# UNITED STATES PATENT AND TRADEMARK OFFICE

APPLICATION NO.	FILING DATE	FIRST NAMED INVENTOR	ATTORNEY DOCKET NO.	CONFIRMATION NO.
10/713,665	11/17/2003	Milan J. Vavra		9840

<b>Office Action Summary</b>	<b>Application No.</b> 10/713,665	<b>Applicant(s)</b> VAVRA, MILAN J.	
	<b>Examiner</b> Robert P. Swiatek	<b>Art Unit</b> 3643

### **DETAILED ACTION**

FIG. 2

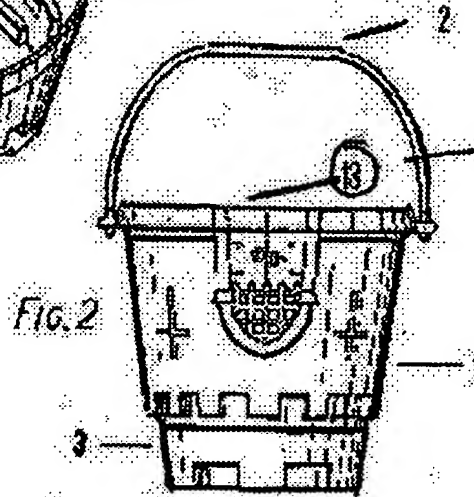
Element 13  
added
